### A WATERWAYS RESPONSE TO THE OVERDEVELOPMENT OF 2-6 ST PANCRAS WAY, NW1

LB Camden Planning Application Ref: 2017/5497/P – **OBJECTION**

Planning Application Ref: 2017/5497/P  
2-6 St Pancras Way, NW1

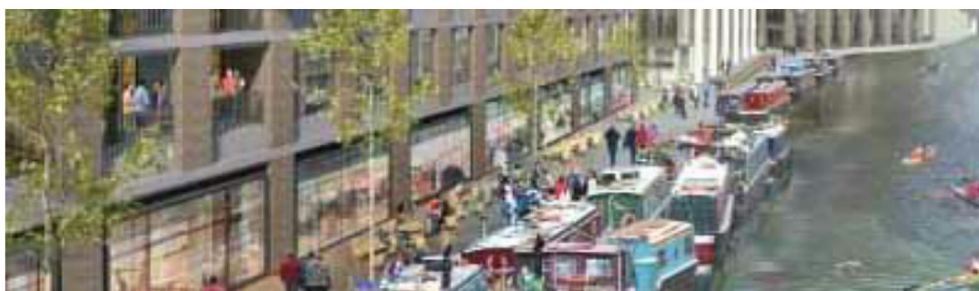
Not only are the proposed buildings far too high and shut the Regents Canal in, they are not a pretty

sight, and are very unsuitable for the special character of the admired canal. They just do not fit in and seem to be ‘off the shelf designs’ rather than carefully and individually designed to suit the heritage waterside setting and to complement it.

Are the people shown in the illustration walking along the towpath admiring the huge edifices or just tolerating them? Perhaps the children are being shown examples of current architecture to admire.

Regardless of the aesthetics the sad fact is that the sky is blotted out and the sunshine is seriously compromised. Just imagine how clear and refreshing the same scene would be without those buildings dominating the view, and with the sky and the canal the main features.

It is plain to see from the illustration that even if the buildings were half the height they would still be inappropriately enclosing the canal, and still taking away a large patch of sky. This could be resolved if all the buildings when lowered were also set well back from the canal edge, preferably much more than the width of the towpath opposite, which is a bit restrictive (historically!). This would result in retaining the open character of the Regents Canal as required in the London Plan policies which categorise London’s Blue Ribbon Network as ‘open space’ with the same consideration and protection as a park (LP Policy 2.18, Table 7.2).
